ARLINGTON COUNTY, VIRGINIA

County Board Agenda Item
Meeting of December 12, 2009

SUBJECT: U-3226-09-1 2825 Wilson, LLC for comprehensive sign plan located at 2825 Wilson Boulevard (RPC# 15-065-001).

C.M. RECOMMENDATION:

D WINDOW GRAPHICS - HISTORICAL PHOTOS
QTY: 1 126.5 SQ FT

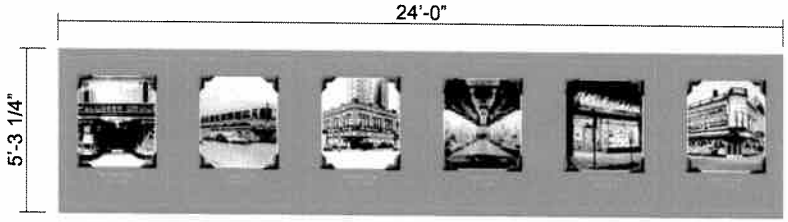
Window Signs: The applicant proposes to locate historic photographs in two (2) of the store's display windows fronting Wilson Boulevard. One bay of windows directly adjacent to the sidewalk would include three (3) images depicting history significant to Arlington. Another bay of windows, set back near the entrance of the store, would include at least three (3) historic photographs relevant to Arlington and up to three (3) relevant to Walgreens. The black and white historic photographs would be imposed on a red translucent vinyl background. The proposed images would cover 60% of the window area. This is three (3) times the permitted coverage for window signs of 20% of the area of the window. In addition, the placement of photographs in the windows would decrease transparency and therefore be inconsistent with the *Clarendon Sector Plan's* Urban Design Guidelines which provides the following:

- Fenestration: Facades on the ground floor should have clear glass with minimal obstruction from windows, permanent shades, or interior displays. Elements to avoid include tinted or mirrored glass and any glazed surface that requires tinting or mirrored glass or mirror-glazing especially on the ground floor.

- Building Orientation and Frontage Types: Openings in a façade, (e.g. windows) should comprise transparent glass, as opposed to mirrored glass or the like, that permit unobstructed views to interior spaces. Blinds, fabrics, and shelving used along the outside walls of retail spaces should be limited and not diminish the pedestrian's visibility into the retail space, or other space with human activity.

- Signs and Awnings/Canopies: Elements to Avoid: Signs partially or completely covering window displays.

As proposed, the signs do not meet the intent or vision for this area of Clarendon. The store is allowed by-right and therefore does not have a transparency requirement. However, the goal should be to maintain window transparency and 75% façade transparency consistent with the *Clarendon Sector Plan*. Further, the interior layout of the store is such that windows are currently obstructed with store displays and shelving. Therefore, as the store is currently configured, façade and window transparency would be difficult to achieve.

5. The applicant agrees that the window signs shall comprise photographs depicting history significant to Arlington County and that the photographs shall be changed at least two (2) times annually for the life of the use permit.

F GROUND SIGN - EXISTING SIGN PRIOR TO WALGREENS
QTY: 1 25.0 SQ FT

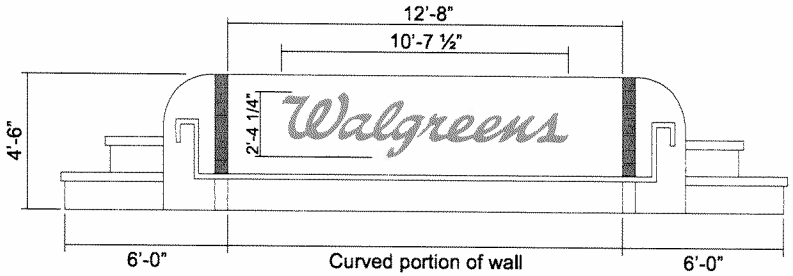
Freestanding Sign: In 1992, with the approval of a use permit for National Tire Warehouse, a comprehensive sign plan was also approved, that included a freestanding, monument sign. The sign comprised the construction of a brick monument base at the corner of N. Edgewood Street and Wilson Boulevard, with aluminum letters no greater than 39 square feet, mounted on a five (5) foot high curved brick screening wall which extended 26 feet. It was recommended at the time of approval that the screening wall be reduced in height to four (4) feet and that the sign include directional information to encourage vehicular use of the Wilson Boulevard entrance. While a sign permit application was filed and the sign installed as approved through the use permit process, the sign permit was never obtained.

Similar to the sign approved in 1992, which remained on the site until 2007, Walgreen's proposes to install a 25 square foot monument sign on the existing curved screening wall to include channel mounted, red script letters that would be internally illuminated. The screening wall, which was previously painted in shades of blue, gray and yellow has been painted white and is covered, as the new sign was installed prior to determination that it required County Board approval. The Zoning Ordinance permits freestanding signs in "C" districts subject to specific parameters and criteria, and only for: 1) unified shopping centers in single ownership or control, 2) automobile service station uses, and 3) lots used for motor vehicle sales, landscape sales or sale of other merchandise typically displayed outdoors. This would be consistent with the history of uses and placement of a freestanding sign on the property. However, the current use does not meet any of these criteria. Additionally, a freestanding sign on a site that already provides considerable sign area, geared primarily to automobiles, is less desirable than a sign that would enhance the pedestrian experience.

3. The applicant agrees that the freestanding monument sign at the corner of Wilson Boulevard and N. Edgewood Street shall be landscaped with evergreen shrubs, perennial ground cover and seasonal flowers planted in an area not less than three (3) feet in width around the base of the sign. The applicant shall submit for review a revised landscape plan to be approved by the County Manager or designee.

4. The applicant agrees that the freestanding monument sign shall not be internally illuminated but shall be illuminated by ground floor lights only as shown on the drawings prepared by Icon Identity Solutions titled *Walgreens Comprehensive Sign Plan* dated September 24, 2009.
